COUNTY OF MENDOCINO

# MEMORANDUM

SUBJECT: MHRB\_2021-0003 & MHRB\_2021-0018, Minor Alterations, MCDOT Encroachment

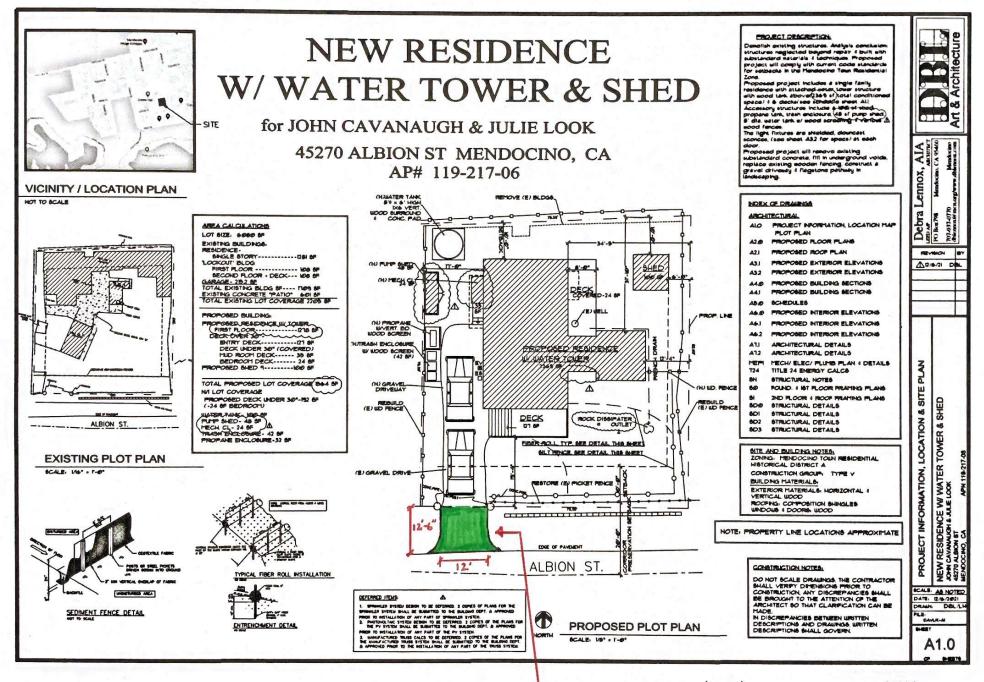
Please see attached site plan showing the proposed asphalt driveway approach per Mendocino County Standard A51A. Mendocino County DOT standard is for 15' of paving from the edge of pavement, however we are fine with the paving ending at property line (12'-6") as shown highlighted in green. Please let me know once it has been accepted by MHRB, so I can proceed with issuing an encroachment permit for this work within the County Right of Way. This work is already exempt from needing a CDP per CE\_2021-0027.

Per our conversation yesterday, please see the attached site plan showing the dimensioned asphalt. Following our conversation, I did speak with Jesse from Planning and she told me that this would need to run through MHRB and that they have 1 meeting per month. On my side, this makes the process more time sensitive, so please let me know if you need anything else from me to push this through to her.

- NEW ASPHALT PER MENDOCINO COUNTY STANDORD ASIA

Per MCDOT requirements, the required asphalt driveway approach per Mendocino County Standard A51A is for 15' of paving from the edge of existing pavement. However, MCDOT is allowing a reduced driveway approach of only 12' 6", which will end the paving at the property line as shown in green highlight on the proposed site plan (Attachment B).

**<u>RECOMMENDATIONS</u>**: Staff recommends the Review Board consider granting a concurrent variance and adopt recommended minor alterations to allow for a reduced asphalt driveway to serve the single-family residence allowed pursuant to MHRB\_2021-0003 and MHRB\_2021-0018 permits.
